The west half is done and it verifies itself. Your “shower behind the washing machine” was the key — it squares the whole master suite and the column closes to two inches against the measured west wall.

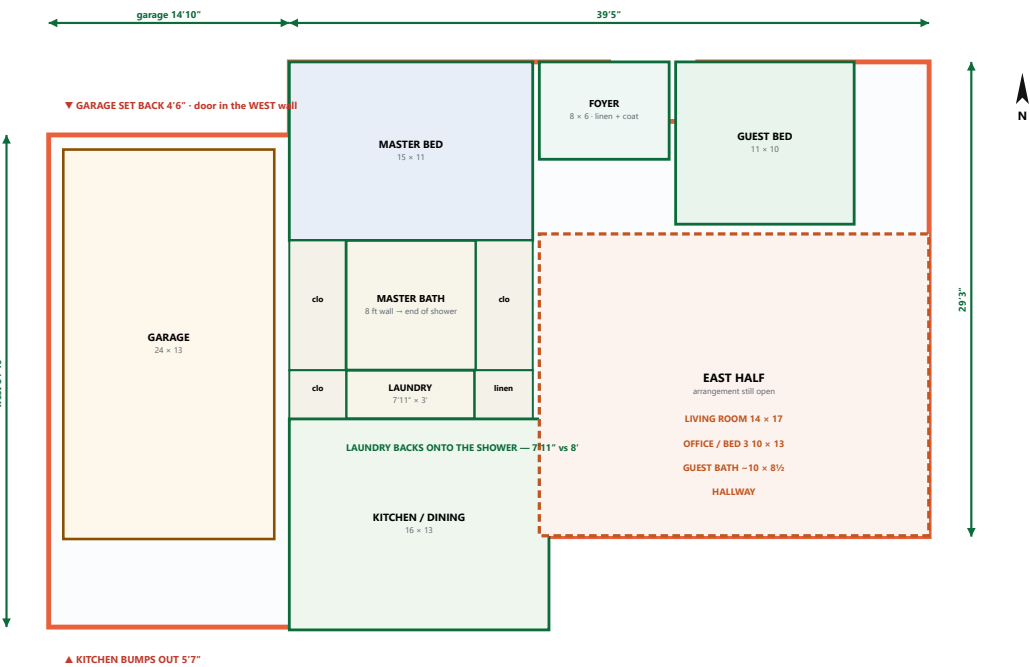
✓ THE WEST COLUMN CLOSES TO 2 INCHES. Stack what you described and it lands on the measured wall by itself — I did not force it:

master bed	11.0
master bath, wall → end of shower	8.0
laundry alcove	3.0
kitchen / dining	13.0
TOTAL	35.0
MEASURED west side	34.83 ← 2 in apart

That is an independent check, not an assumption. Four numbers you measured separately, stacked in the order you described, hitting a fifth number you measured separately.

🔑 And the widths lock too. The shower run is 8 ft; the laundry is 7'11" — one inch apart, which is what “right behind the washing machine” has to mean. Closets take the remaining 7 ft of the 15, one on each end of the shower as you said, with the linen closet beside the laundry and a coat closet in the foyer.

⚠ The east half is the whole remaining job, and it is hatched on the plan rather than guessed. Four things go in there — living room 14×17, office 10×13, guest bath ~10×8½, and the hallway — and they do not fit the way I had them:

guest bed 10 + office 13 + bath 8½	= 31'6"
east side measures	29'3"
over by	2'3"

So all three cannot sit against the east wall. One of them opens off the hallway instead. Which one?

No more tape needed. Just walk the east half and tell me the order — what you pass coming out of the hallway. Then the device key and the reworked duct drawing both fall straight out of this.
